DART AEROSPACE LTD		Work Order:	136984
Description: Crosstube Assembly, Mid Fwd		Part Number:	D206-667-147
Inspection Dwg: D206-667-147 Rev: A		Page 1 of 2

DART AEROSPACE LTD HAWKESBURY, ONTARIO, CANADA	
DRAWING NO. D206-667-147	REV. A SHEET 1 OF 4
TITLE CROSSTUBE ASS'Y (206L MID FWD)	SCALE NTS
COPYRIGHT © 2010 BY DART AEROSPACE LTD THIS DOCUMENT IS PRIVATE AND CONFIDENTIAL AND IS SUPPLIED TO THE EXPRESS CONDITION THAT IT IS NOT TO BE USED FOR ANY PURPOSE OR COMMUNICATED TO ANY OTHER PERSON WITHOUT WRITTEN PERMISSION FROM DART AEROSPACE LTD.

DRAWING NO. D206-667-147	TITLE CROSSTUBE ASS'Y (206L MID FWD)	REV. A	DART AEROSPACE LTD ENGINEERING ORDER		D.E.O. NO. D206-667-147-A-1	SHEET NO. SHEET 1 OF 1	SCALE NTS
DRAWN <i>qp</i>	CHECKED <i>ADS</i>	MFG. APPR. <i>JS</i>	APPROVED <i>MD</i>		DE APPR. <i>MD</i>		
DATE 11.07.15	DATE 11.07.20	DATE 11.07.21	DATE 11/07/21		DATE 11.07.21

DRAWING NO. D206-667-147	TITLE CROSSTUBE ASS'Y (206L MID FWD)	REV. A	DART AEROSPACE LTD ENGINEERING ORDER	D.E.O. NO. D206-667-147-A-2	SHEET NO. SHEET 1 OF 1	SCALE NTS
DRAWN AJS	CHECKED	MFG. APPR.	APPROVED	DE APPR.		
DATE 12.08.02	DATE 12.08.02	DATE 12.08.02	DATE 12.08.02	DATE 12.08.02	DATE 12.08.02

DETAIL P
BONDING STRAP INSTALLATION 2 PL

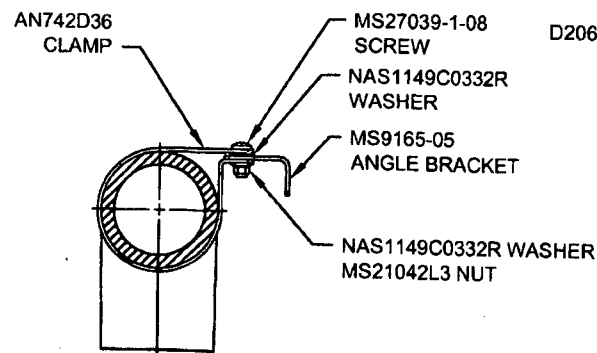
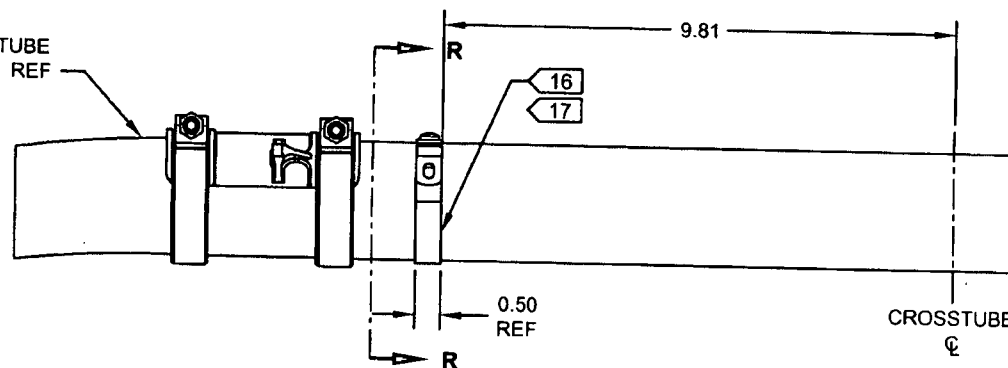
ADD ELECTRICAL GROUNDING STRAP

ITEM	QTY -147	PART NUMBER	DESCRIPTION	
1	X	D206-667-147	CROSSTUBE ASSEMBLY (206L MID FWD)	
10	2	AN742D36	CLAMP	} ADD
11	2	MS9165-05	ANGLE BRACKET	
12	2	MS21042L3	NUT (OR MS21042-3)	
13	2	MS27039-1-08	SCREW	
14	4	NAS1149C0332R	WASHER (OR AN960C10L)

- 16) MASK AREA UNDER CLAMP PRIOR TO PAINTING
17) SEAL EDGES WHERE AN742D36 CLAMP MEETS WITH THE CROSSTUBE USING SIKAFLEX-241/-291 OR MIL-S-8802 CLASS B2 OR PROSEAL 890 SEALANT
18) PERFORM RESISTANCE CHECK TO ENSURE MAX RESISTANCE IS 10 MILLIOHMS
- AFT
- } ADD
